STAFF REPORT

CITY OF HUBBARD PLANNING COMMISSION

FILE No.: Site Development Review, file #DR 2022-02

REQUEST: Site Development Review approval for two abutting properties. Address 2363 is developed with an existing 15,000 SF office/warehouse building, a 12,600 SF warehouse building, parking, landscaping, and outdoor storage area. Address 2347 is a vacant undeveloped field. Applicant proposes to develop a fenced gravel yard on 2347 for outdoor storage of electrical materials and equipment, in support of an electrical supply warehouse and distribution company occupying both lots.

PRELIMINARY SITE & UTILITY PLAN

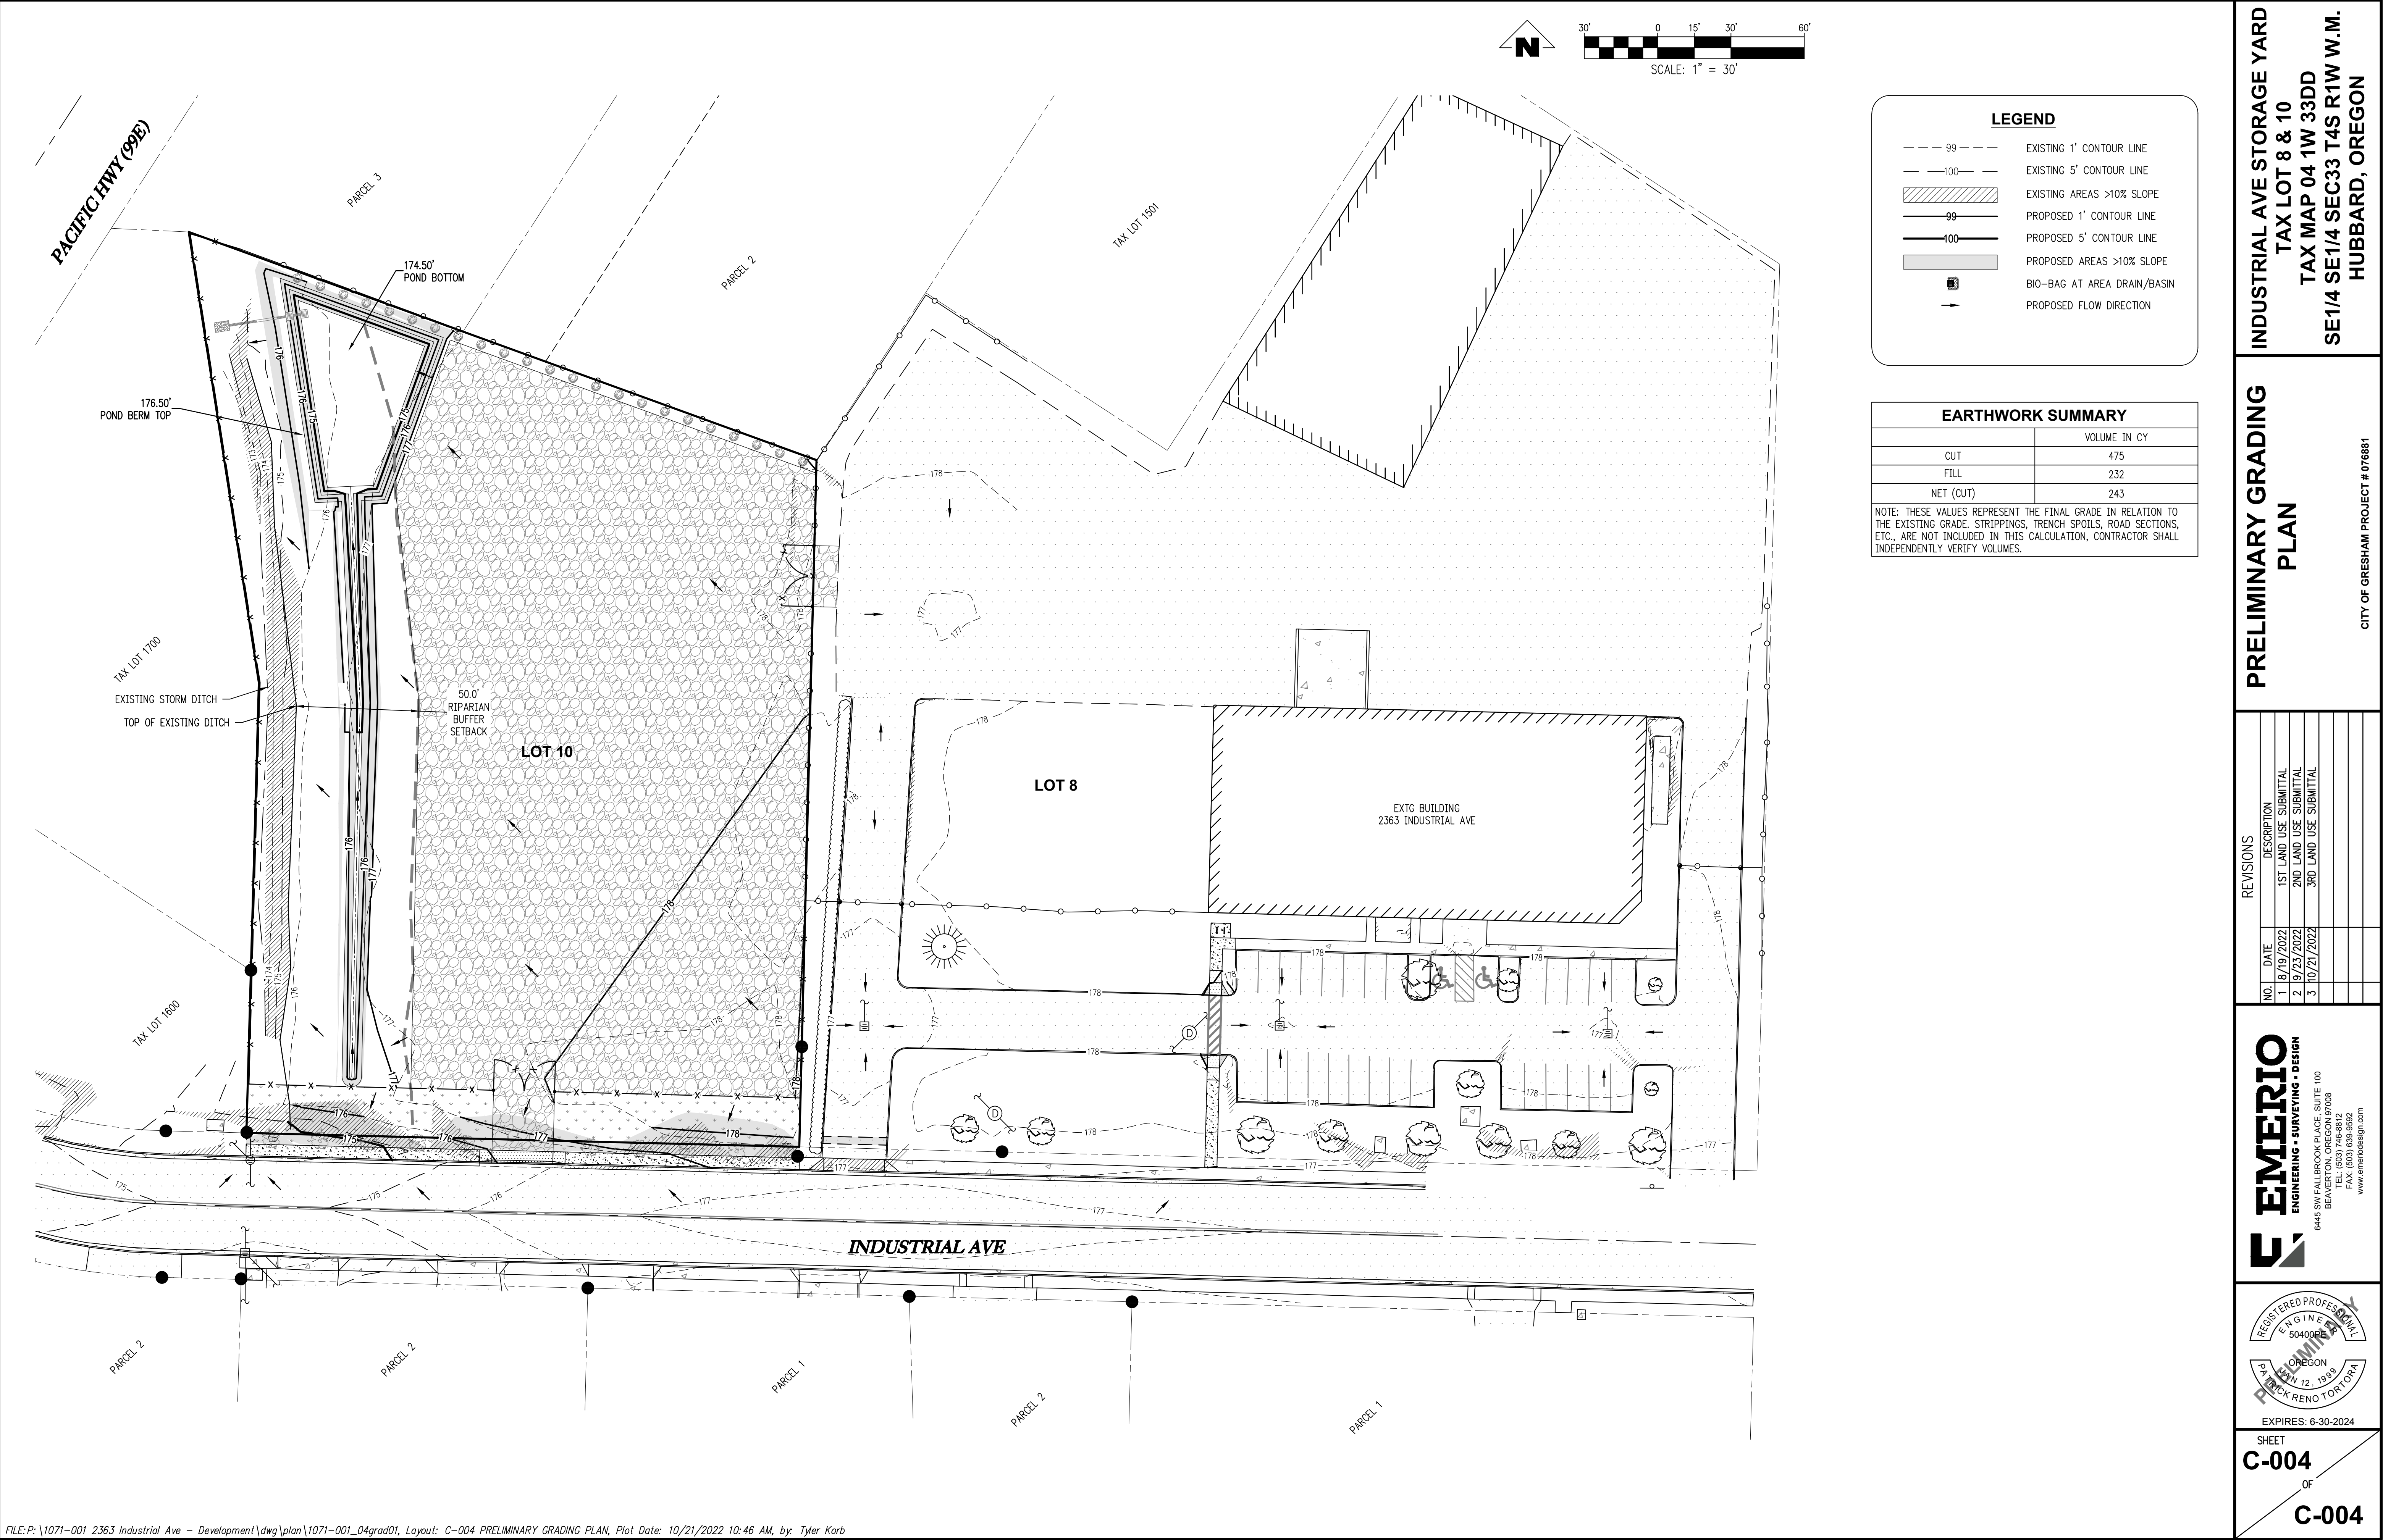
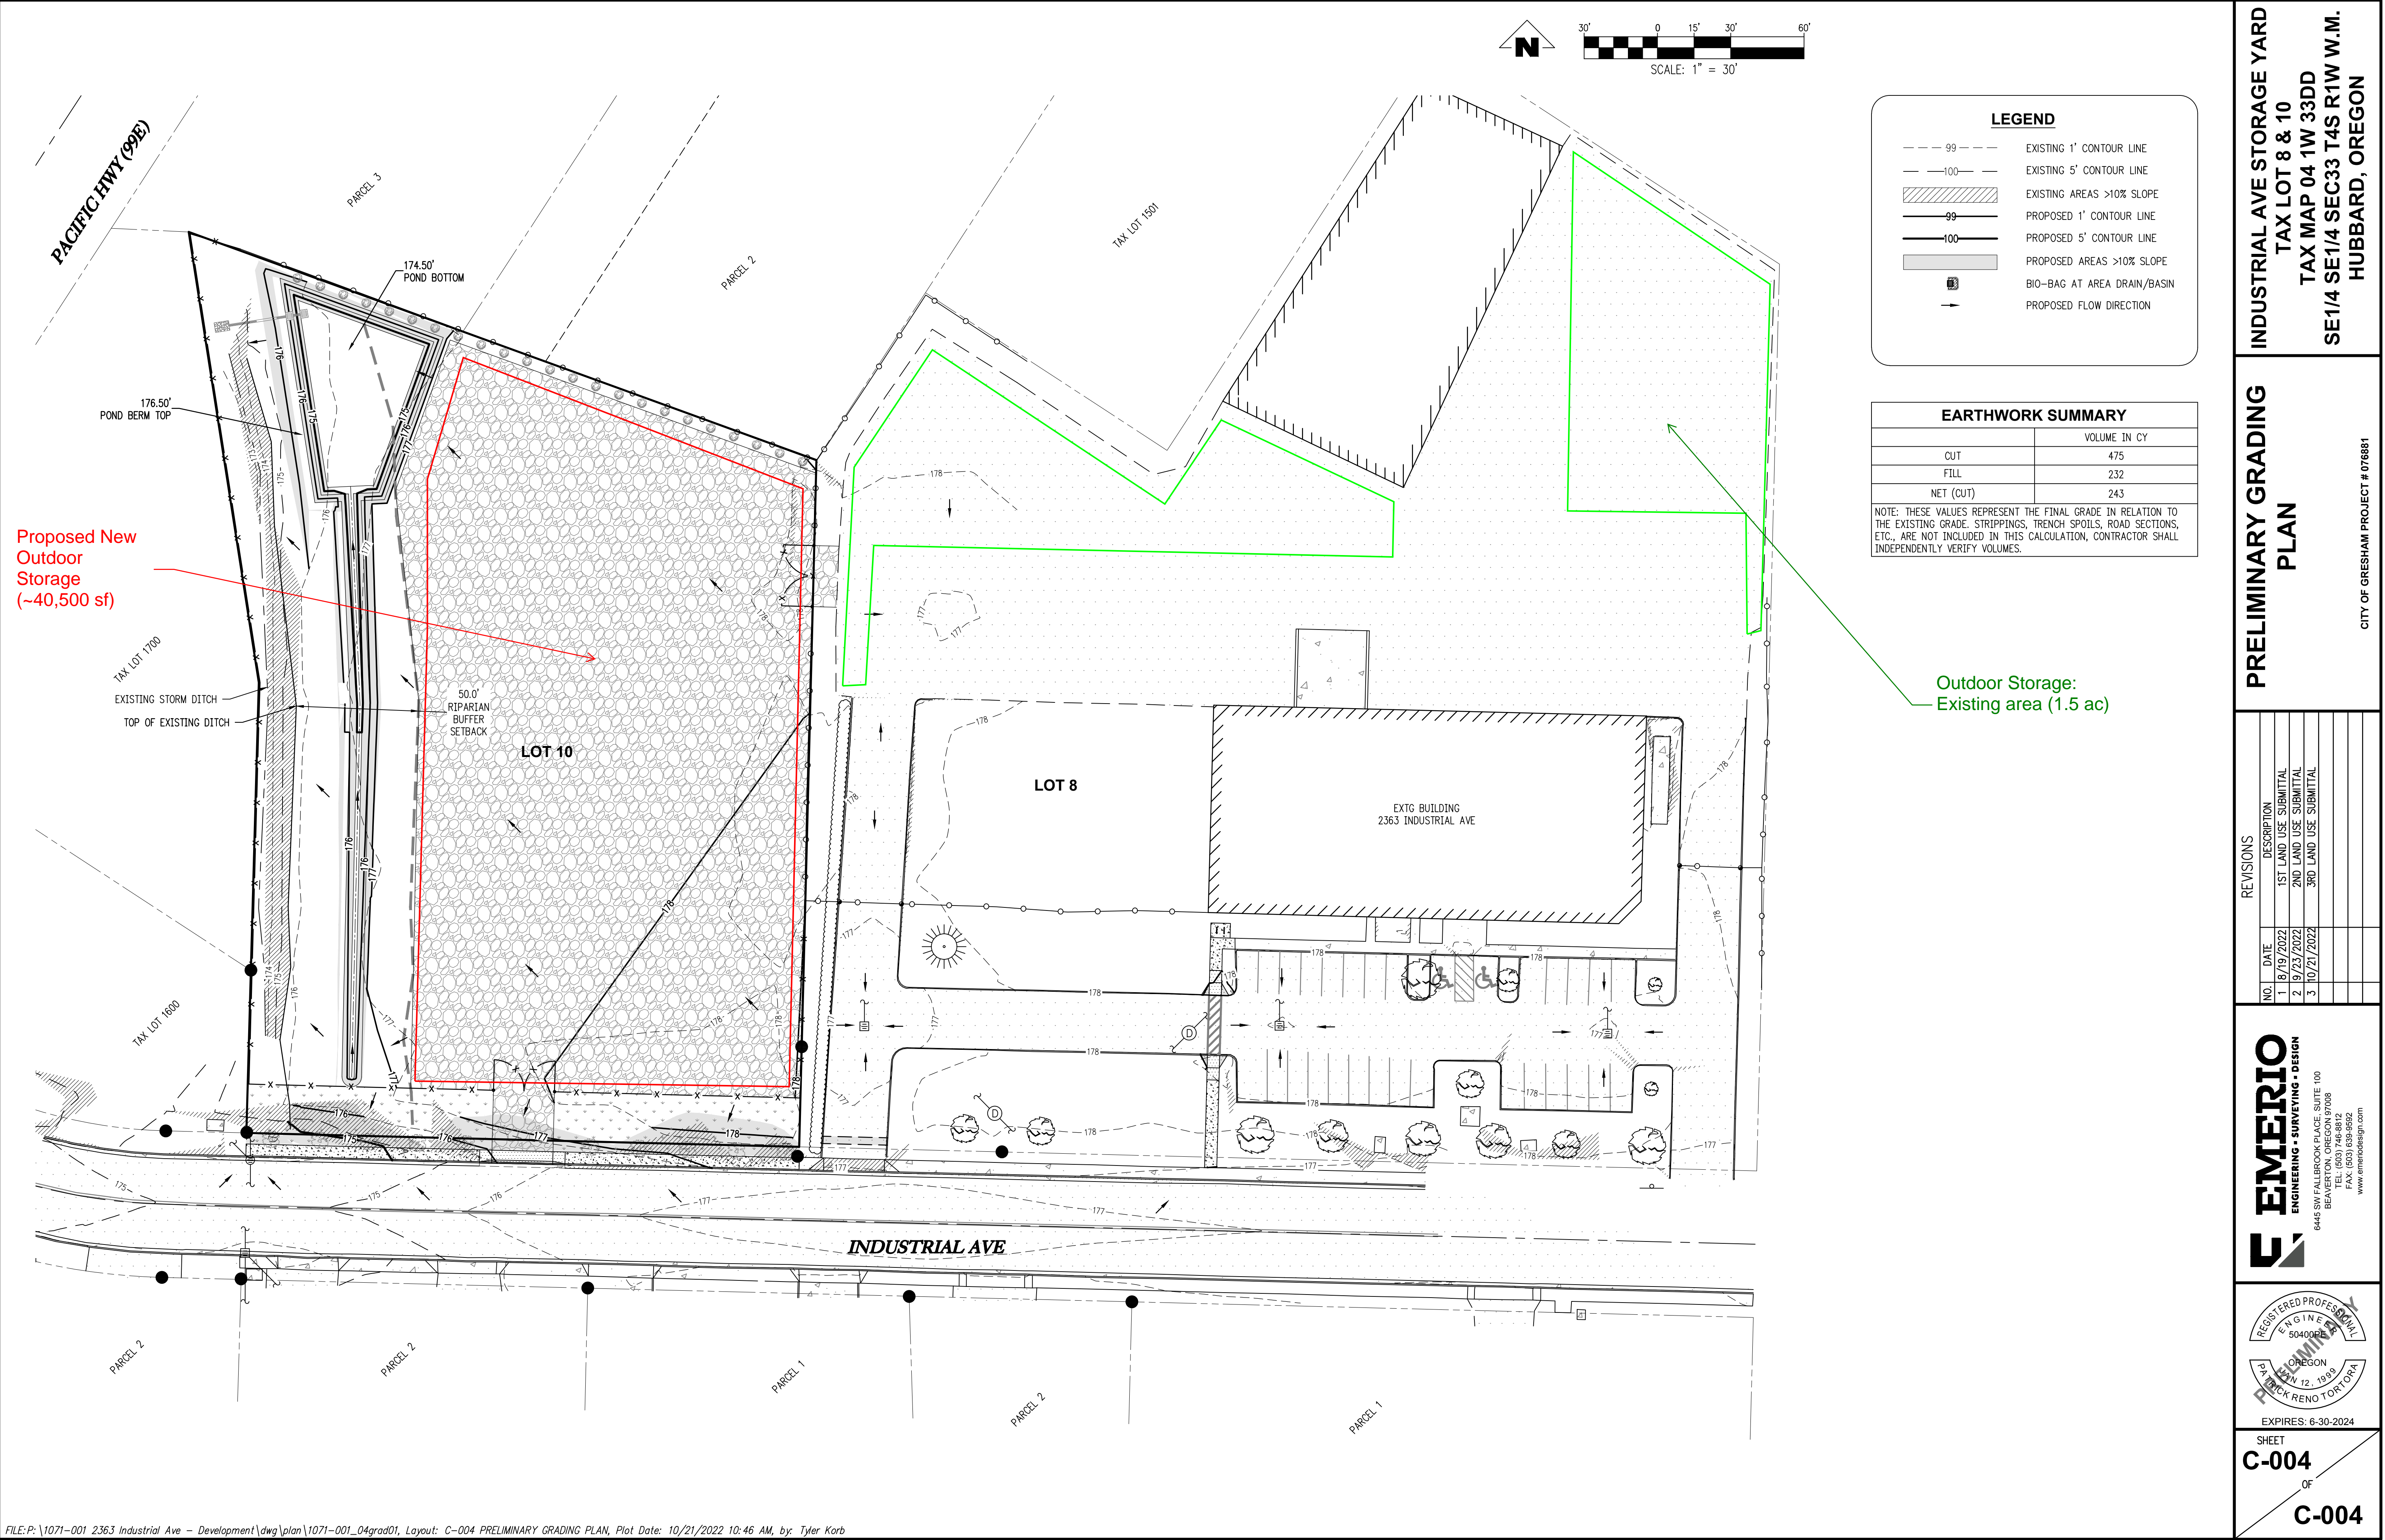
- Drainage Report; page 4 references Bear Creek PUD. Please revise to reference this project.
- Preliminary Site Improvement Plan; Title block references site in Gresham, please revise to Hubbard.
- Note, on final design drawings, provide additional on drainage outlet from basin.
- I agree, It would be good to require them to traverse 30-40 feet of pavement prior to entering the public street. Otherwise all that gravel will end up being “dropped” on the public street.
- I agree, it doesn’t seem like a true “parking lot”, so I’d be inclined to allow it in this application [gravel storage yard].

- Lighting plan to be submitted during final engineering or as conditioned
- Please indicate bicycle parking on site plan.
 - Bike parking is noted on the plans (keynote 19 on sheet 3)

- Please show safe pedestrian connection between the office building and the public sidewalk.
 - Additional sidewalk, curb ramp, and striping proposed to bring pedestrians from SW corner of existing TL 1500 building to Industrial Ave frontage (Keynote 17 & 18 on sheet 3).

- Is the species of street tree identified?
 - Street trees and species are noted on sheet 3, keynote 8.

- A note on sheet 3 has been updated to address this item.
- Applicant should expect privacy slats at minimum for screening method along frontage fencing.
